# Improved Smart Card Layout Settings

Affected Version: BioStar 2.9.4 and above
With the new feature [Custom Smart Card] layout added in BioStar 2 Version 2.9.4, there are a few changes and improvements made throughout the [Smart Card] layout as well.

[Before] BioStar 2 Version 2.9.3 and below

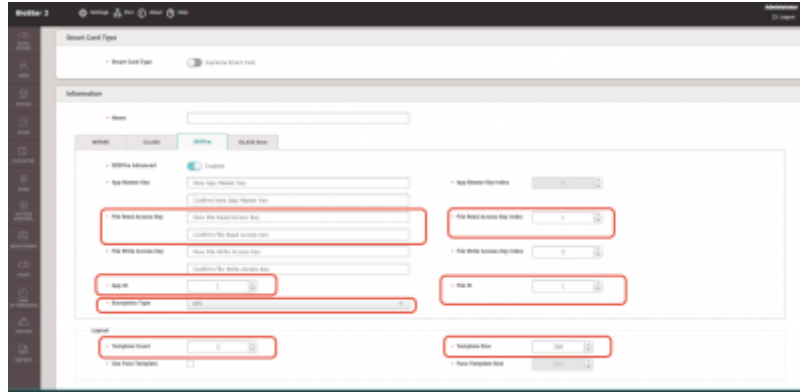
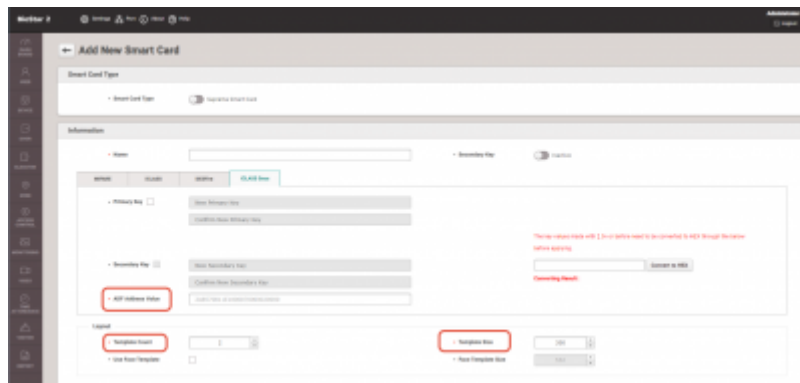
Smart Card Layout Settings for BioStar 2 Version 2.9.3 and below did not separately show (mark) the required field for Smart Card Layout.
With BioStar 2 Version 2.9.4, the smart card settings layout displays the required (mandatory) field value.

Display the mandatory (required) field with red markings in the front, as shown in the image above for the Smart Card layout with MIFARE and iCLASS type of card needed: Name of the smart card, Start Block Index, Template Count, and Template size.

When the DESFire Advanced card is Enabled, File Read Access Key, File Read Access Key Index, App ID, File ID, Encryption Type, Template Count, and Template Size are the mandatory (required) fields.

Note: When the File Read Access Key Index value and File Write Access Key Index are the same, the File Write Access Key data field will be greyed out and display a message stating, "Same as the file read access key."

For iCLASS Seos smart card layout, ADF Address Value, Template Count, and Template Size are mandatory (required) values.
